Memorandum

Re: Request for revocation under 675 IAC 12-5-9

Variance 15-05-69 involves the property located at 520 South 7th Avenue, Vincennes, IN and known as the Good Samaritan Hospital. Variance 15-05-69 specifically deals with access to a freight elevator located on the property. Access to the roof where the freight elevator machine room is located can only be accessed by using a ladder. ASME A17.1 – 2007, 2.7.3.2.1 provides that **“a stairway with a swinging door and platform at the top level, conforming to 2.7.3.3¹,**

Roof
Access
Ladder
and
Hatch

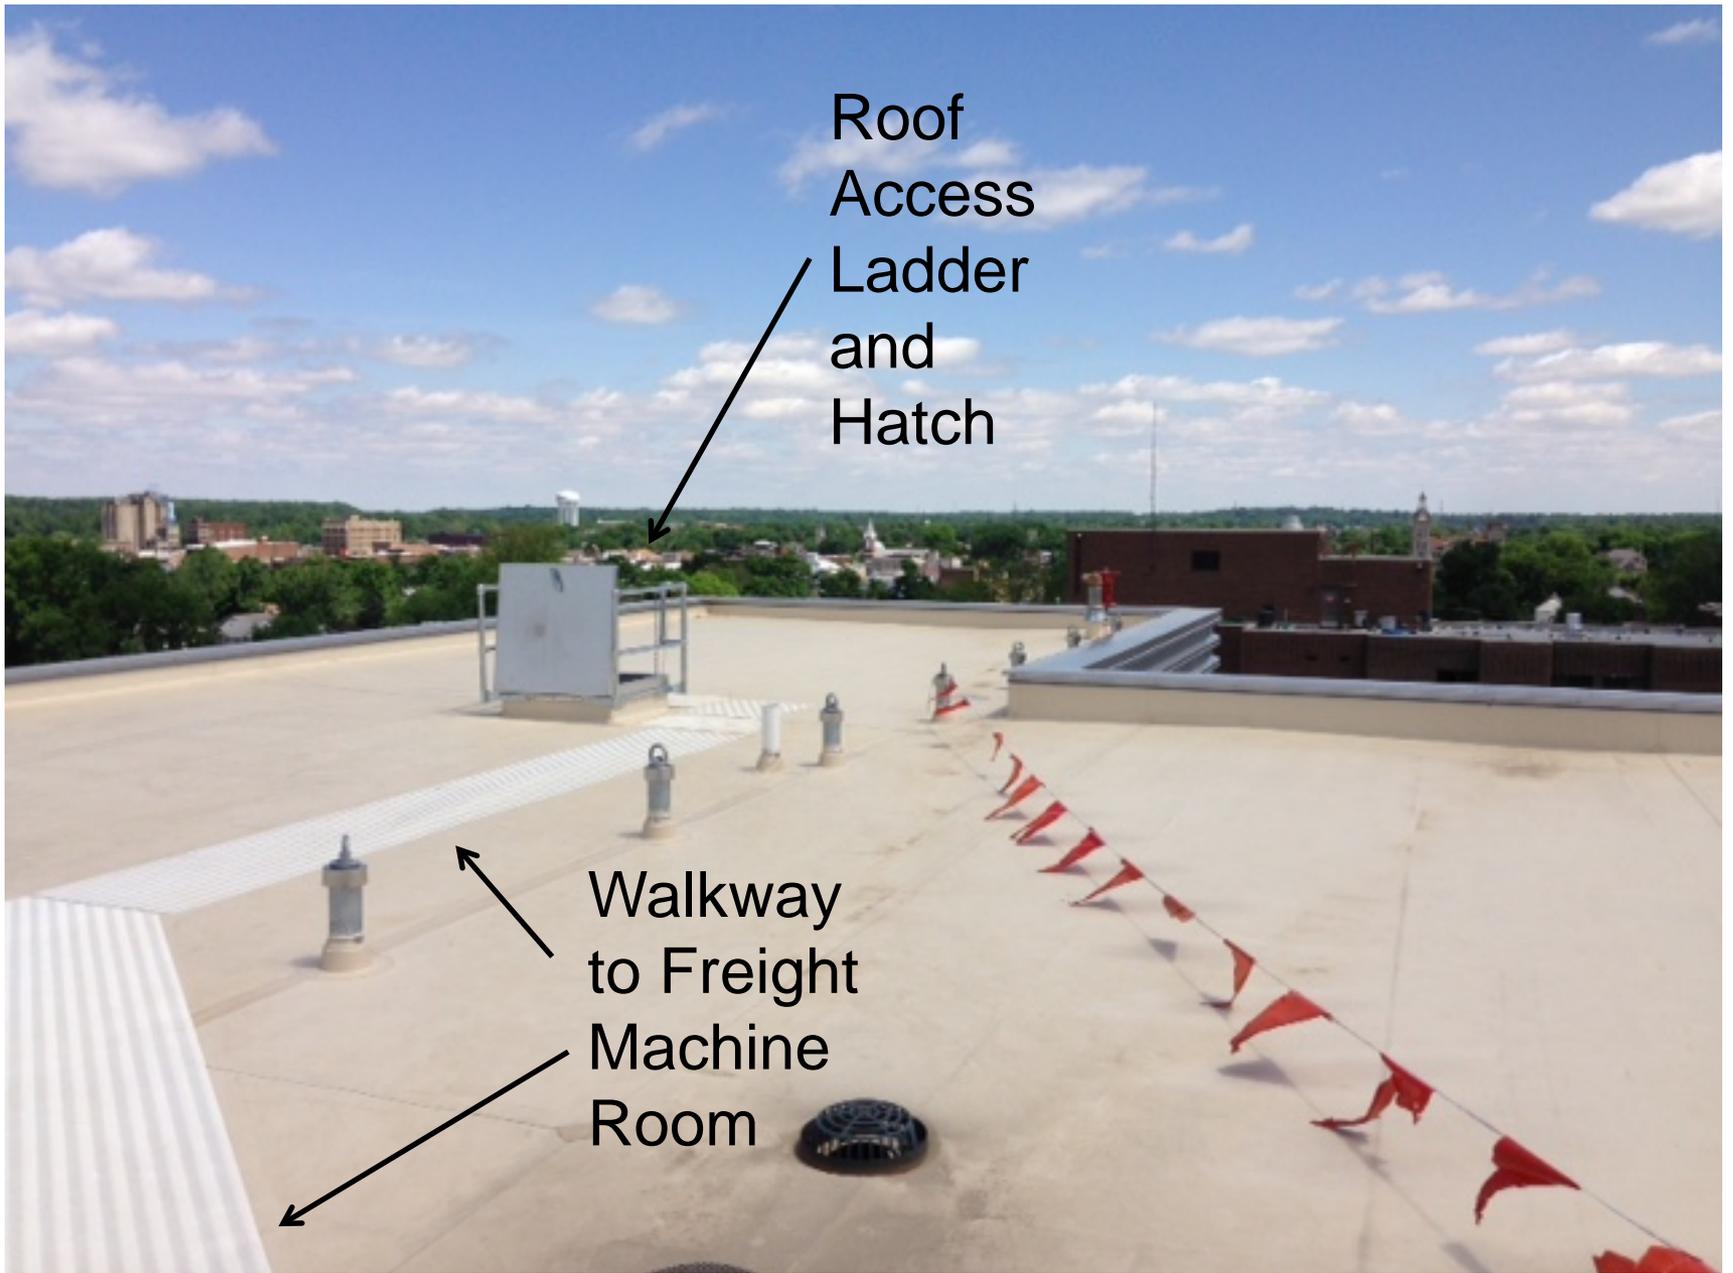
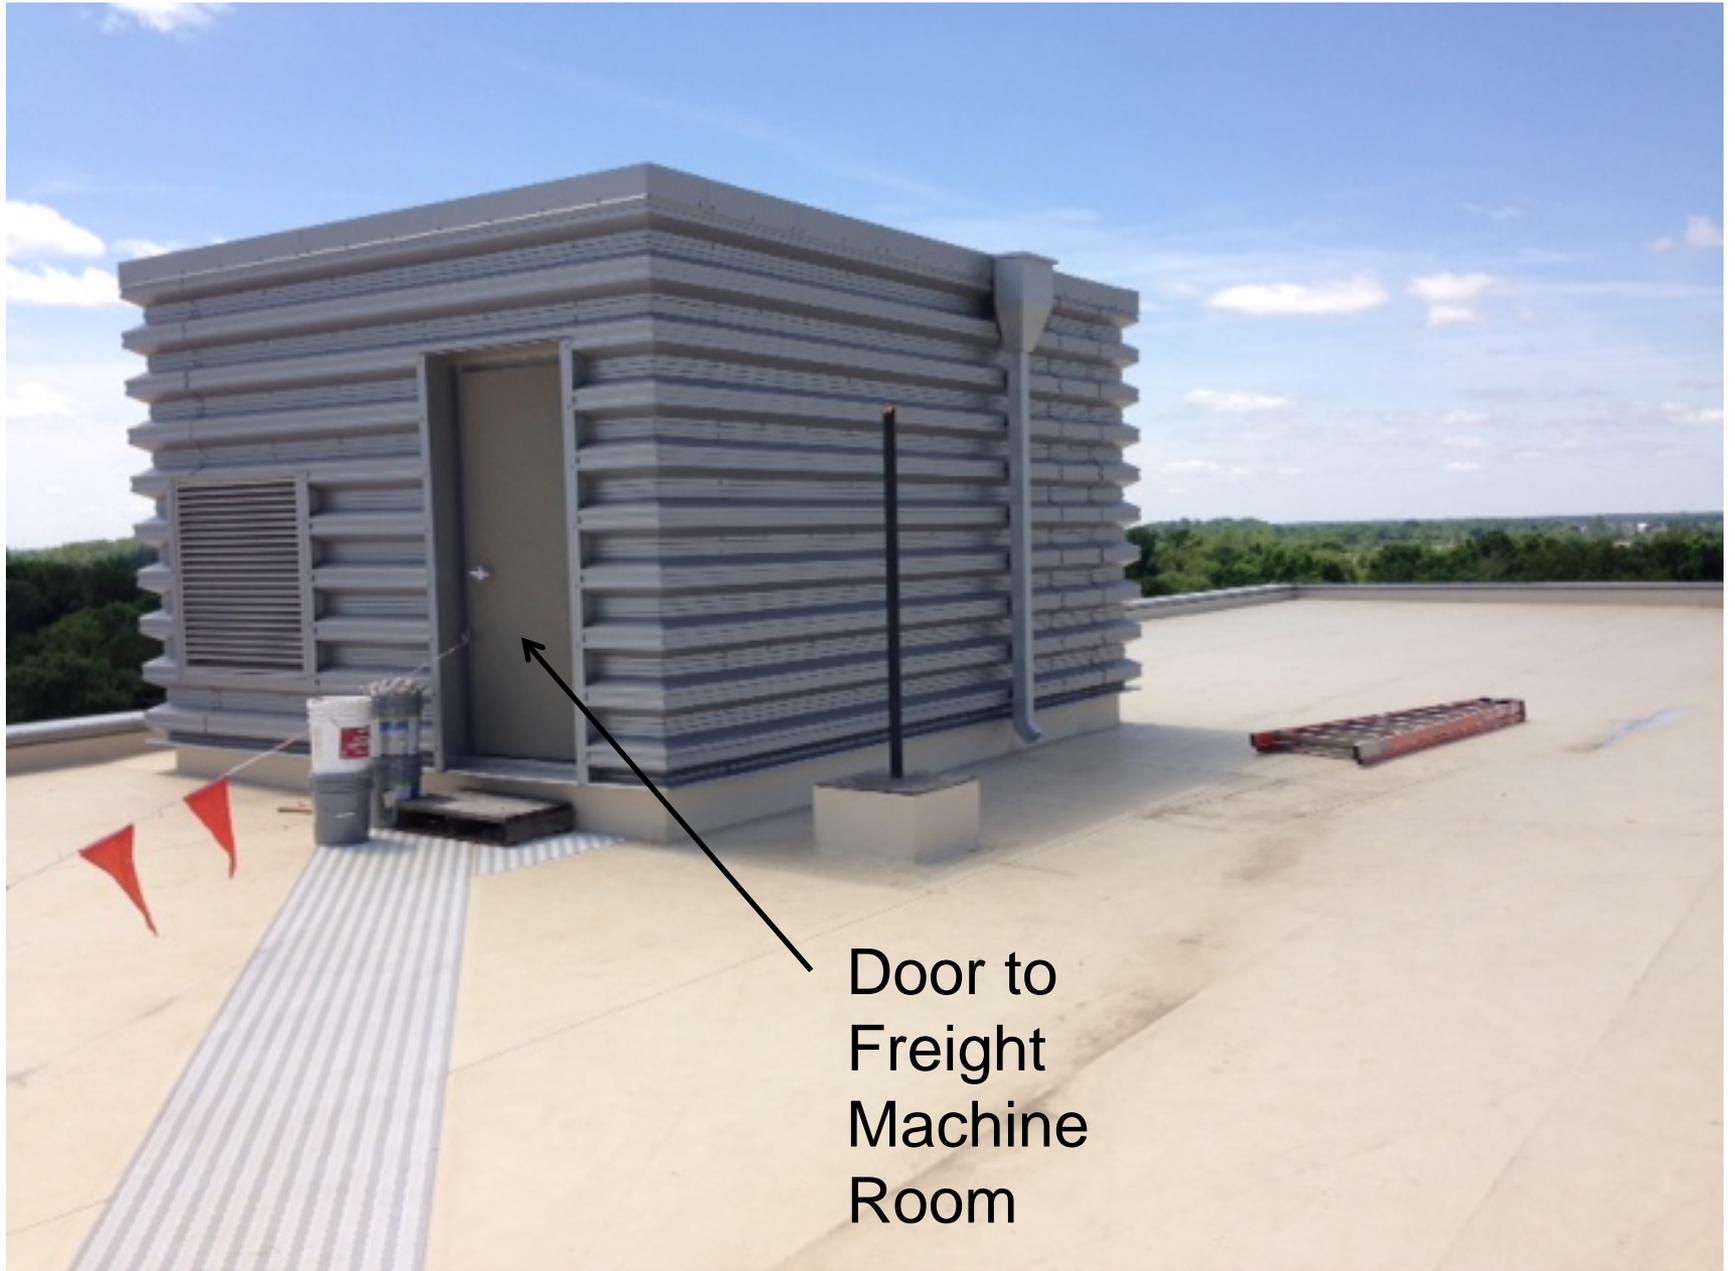
shall be provided from the top floor of the building to the roof level. Hatch covers, as a means of access to roofs, shall not be permitted.” I am requesting that the Commission should review its decision of “no variance required” as it would appear that a variance would be required in this instance. Currently, the freight elevator machine room can only be accessed by using a ladder which would not be compliant to the current code.

Penthouse Mechanical Room

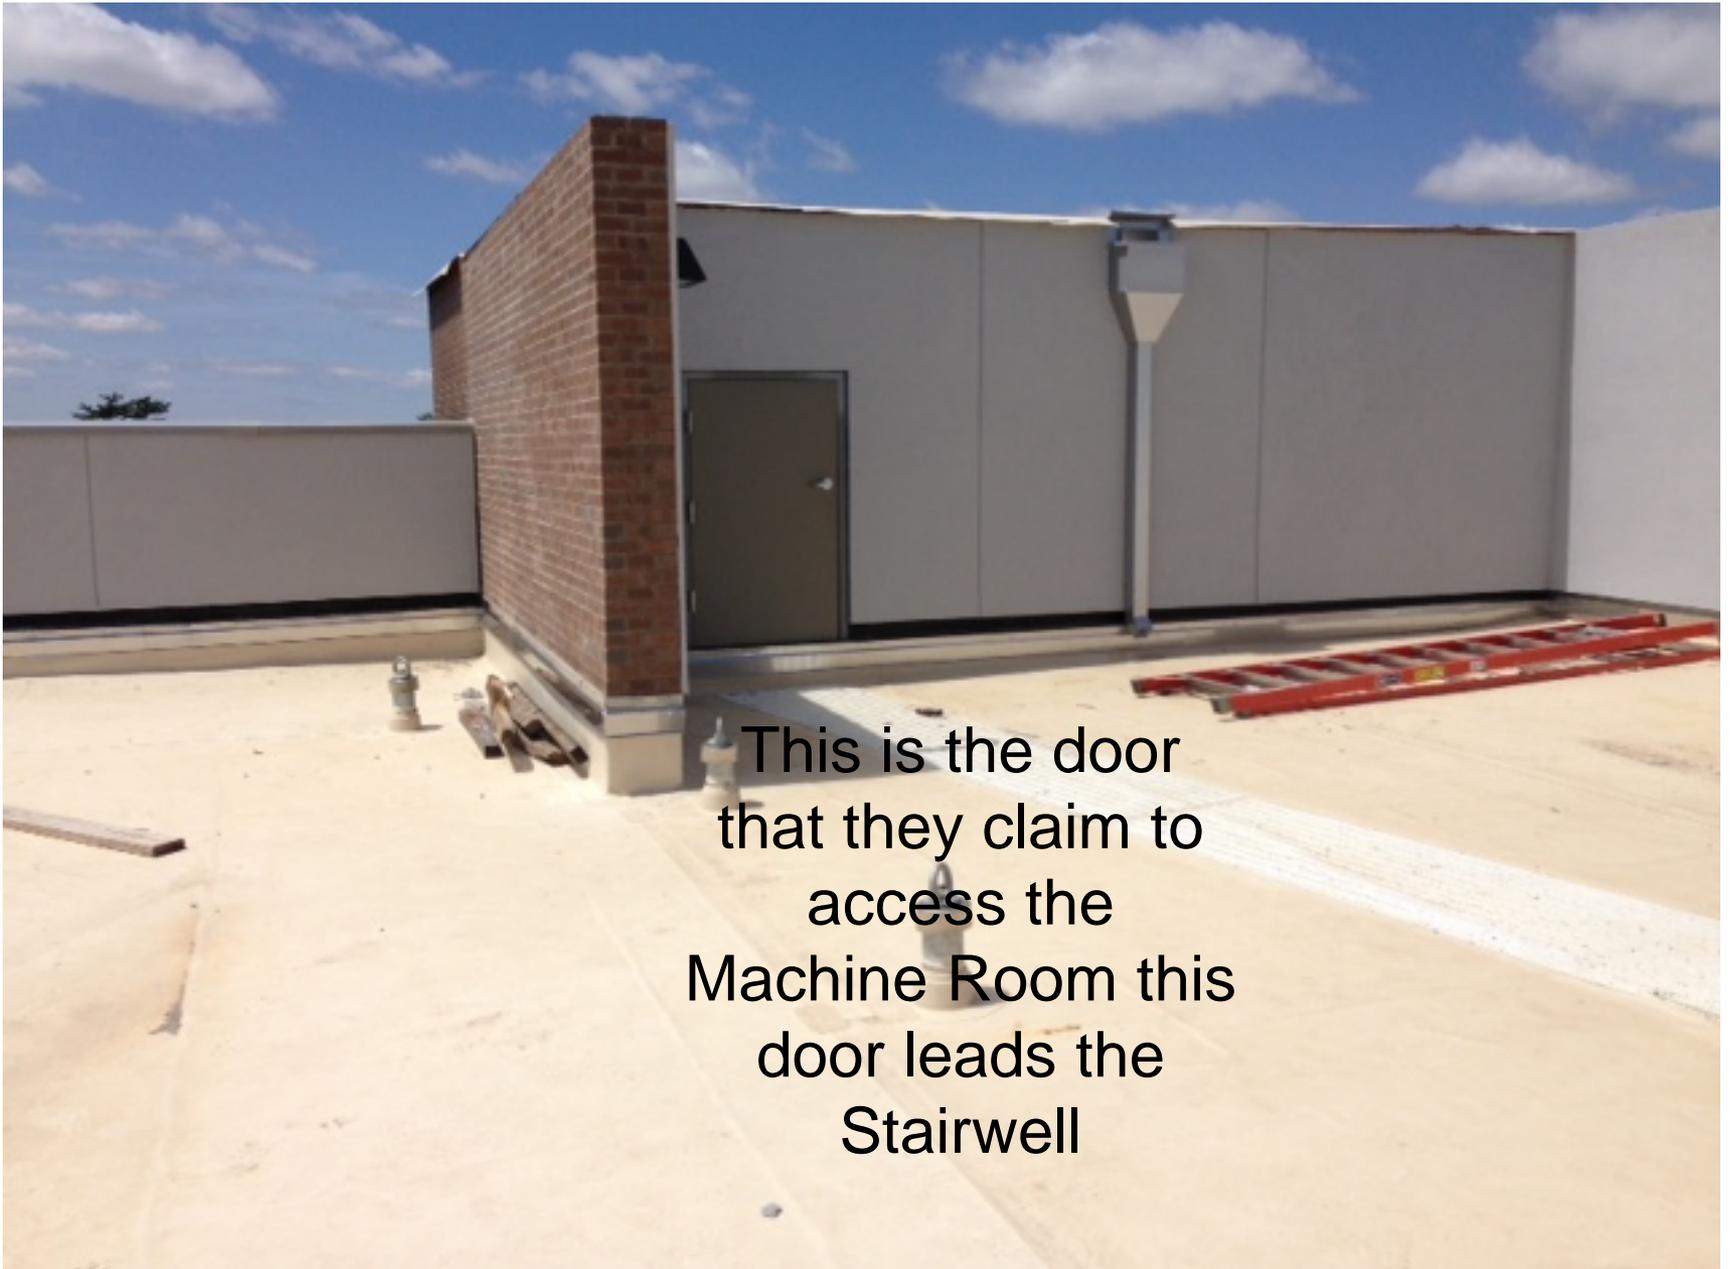
This is the door
that they claim to
access the roof
then the Machine
Room

This is the door
that they claim to
access the
Machine Room this
door leads the
Stairwell
